SUBJECT: Forwards responses to Matls Engineering Branch request for
 addl info re loose parts monitoring sys & concrete
 expansion anchor design. Responses will be incorporated into
 FSAR in Future amend.

Re: St. Lucie Unit 2
Docket No. 50-389
Final Safety Analysis Report
Requests for Additional Information

FLORIDA POWER & LIGHT COMPANY
ST LUCIE PLANT - UNIT NO. 2
MEB REQUEST FOR ADDITIONAL INFORMATION

SUBJECT Concrete Expansion Anchors - Formula for Pipes, Firms with Applied Moment

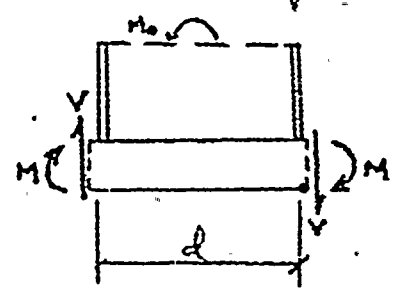
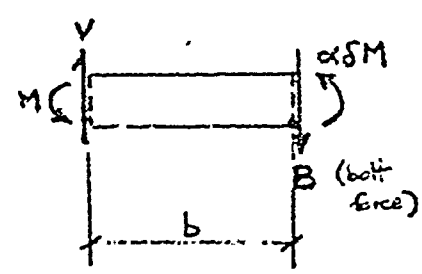
In Section 5 of the Design Criteria for Concrete Expansion Type Anchors define and indicate the method for determining the dimension "d" in the formula using the applied moment. Provide the derivation of this formula.

The parameter "d" used in the applied moment prying formula is defined as the dimension of the attachment in the direction of the moment. For example, in the case of a wide-flange member welded to a base plate and bent about the strong axis, "d" would equal the depth of the member.

See the attached sheets for the derivation of the formulas for α and Q.

Taking a free body of the base plate near the cantilever attachment:

$$\sum M = 0; \quad 2M + Vd - M_0 = 0$$

$$V = \frac{M_0 - 2M}{d} \quad (1)$$

Taking a free body of the base plate from the face of the cantilever member to the tension bolt line:

$$\sum M = 0; \quad Vb - M - \alpha \delta M = 0$$

$$Vb - M(1 + \alpha \delta) = 0$$

$$M = \frac{Vb}{1 + \alpha \delta} \quad (2)$$
